**SOMERSET COUNTY
NOTICE OF ADDENDUM**

**Somerset County 40 North Bridge Street Building
Elevator Modernization
40 North Bridge Street, Somerville, NJ 08876
Contract No. 19023**

ADDENDUM NO. 1

ELEVATOR SHAFT #1 & #2 SECTIONS

1
ELEVATOR SHAFT #1 SECTION
 SCALE: 3/8" = 1'-0"

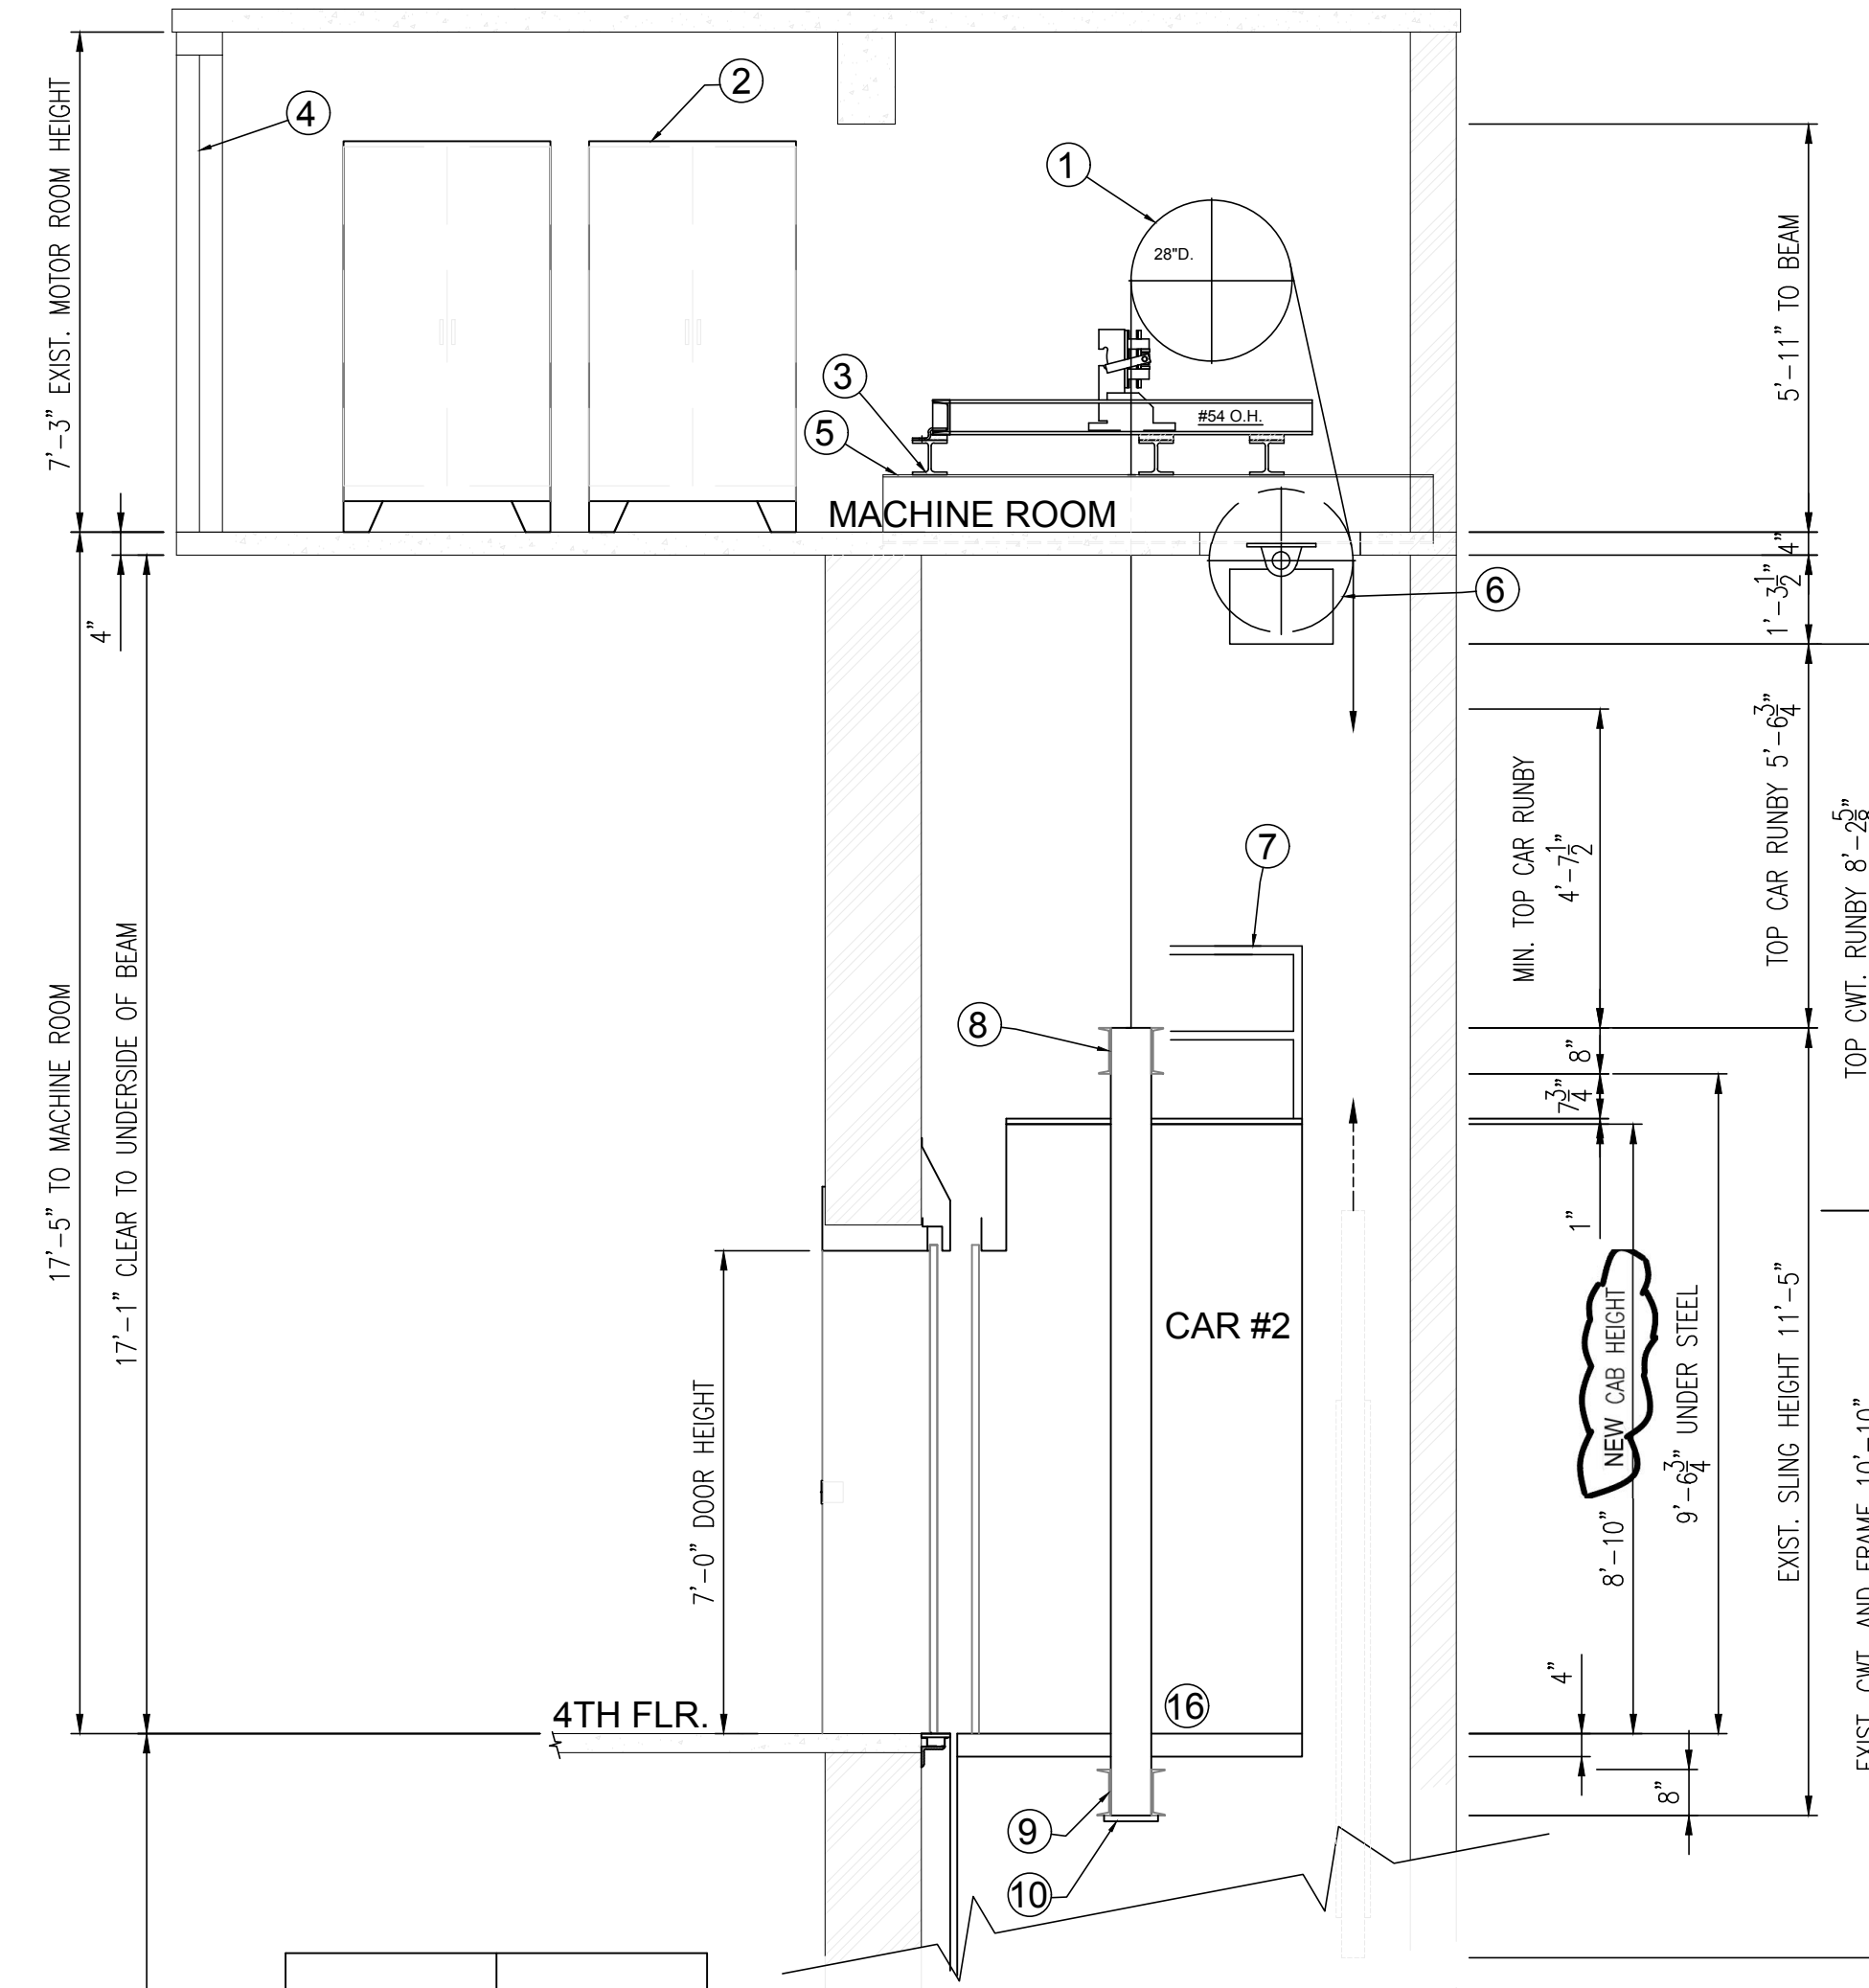
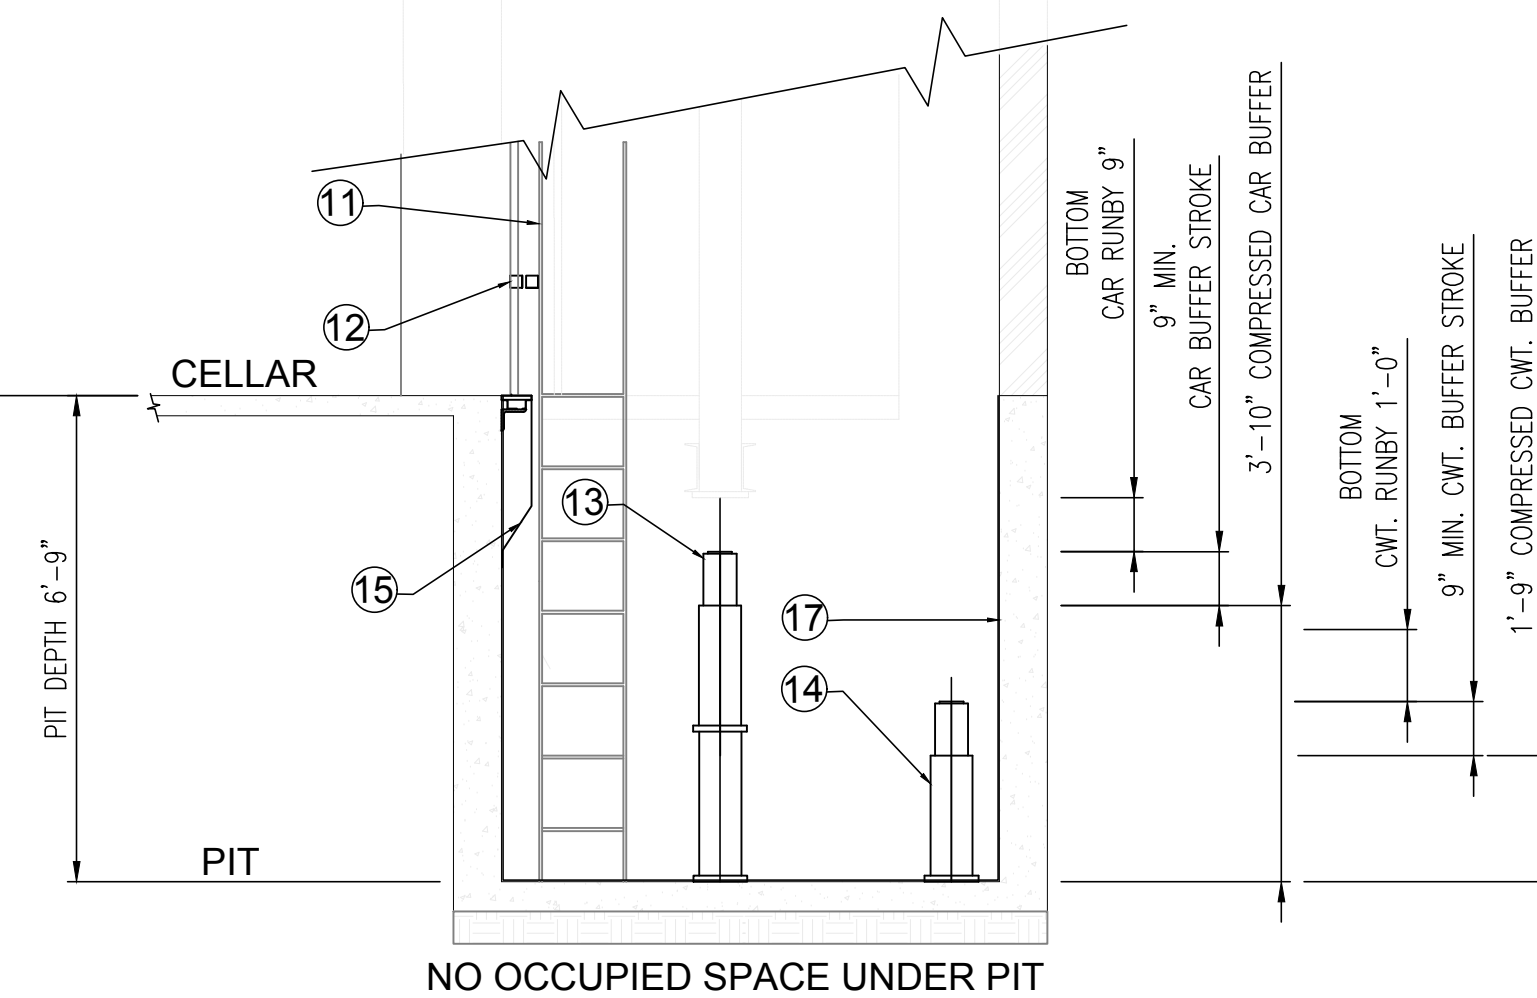
Question 10: It was noted during the project walkthrough the ceiling finishes and cab height of the elevators would be changing. Please advise if these will be altered and provide updated drawings reflecting this change.

Answer 10: Please note that in Section 142123 2.3 A. 4. and plan sheets A108 and A-109 – We are addressing the need to increase the inside cab height to 8'-10" or more if possible. This work will include the removing of the existing ceiling and drop ceiling and replacing with an extension and new ceiling and drop ceiling to increase the cab height. The contract drawings show the new cab height, please note the inside cab height is less than 8'-10" and will require an extension.

2
ELEVATOR SHAFT #2 SECTION
 SCALE: 3/8" = 1'-0"

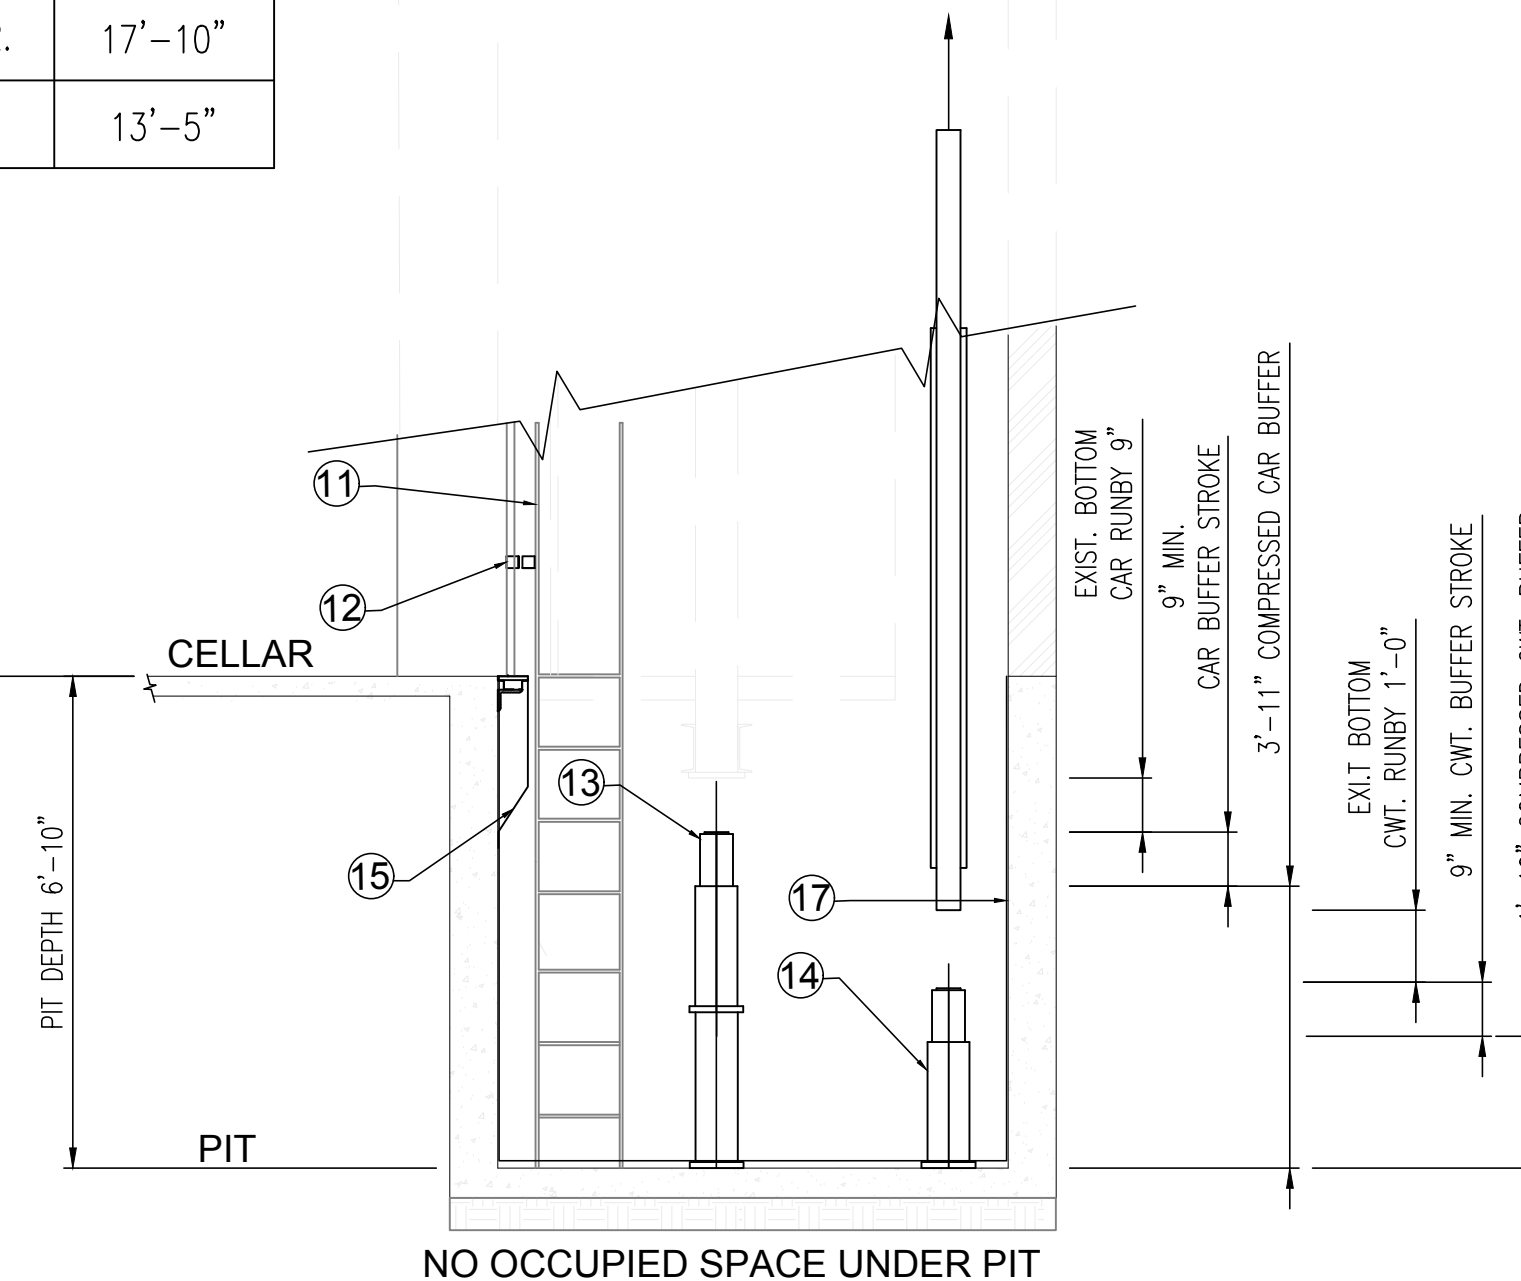
Item 1: Replace plan sheet pg. A-108 with attached plan sheet pg. A-108R.

Within detail 2, elevator #2 section, the wording stating “Existing Cab Height” has been changed to “New Cab Height”.
